## PRODUCT/PROCESS CHANGE NOTICE (PCN)

### ATTACHMENT I - PCN #: TB0711-01

**PCN Type:** Packing Material

**Detail of Change:** This notification is to advise our customers that IDT has qualified new shipping trays for 950 mils x 950 mils PQFP 132L products.

Existing Shipping Tray

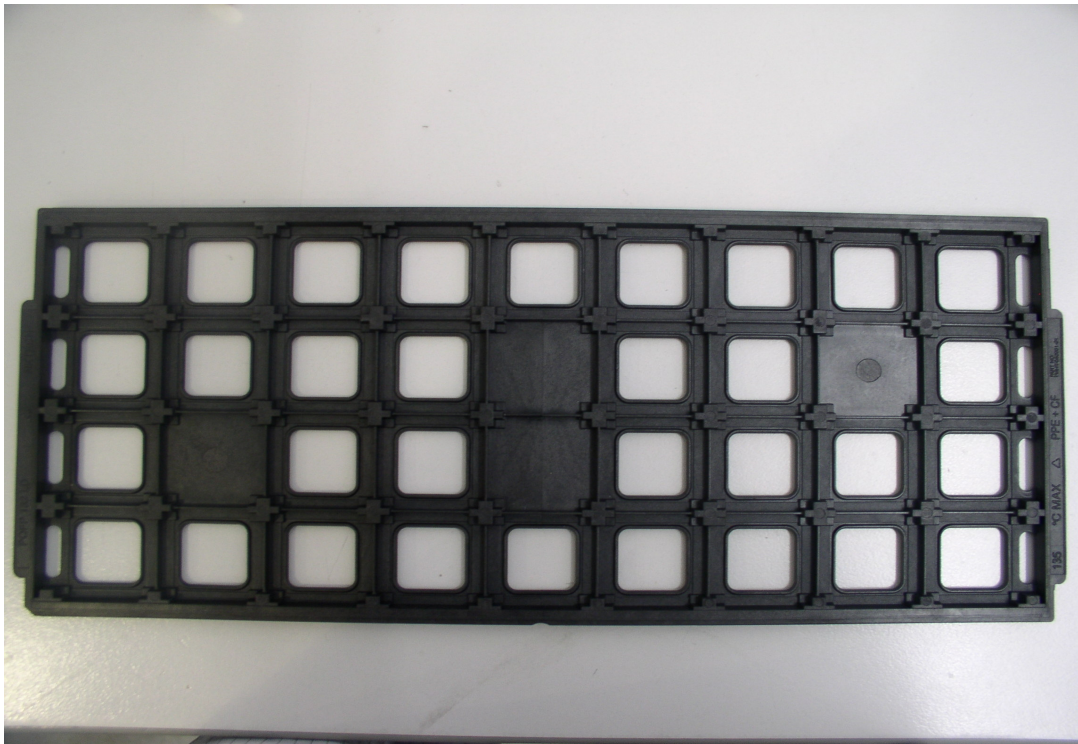
There is no change to the number of units per tray and tray dimensions but changes to the tray withstand temperature.
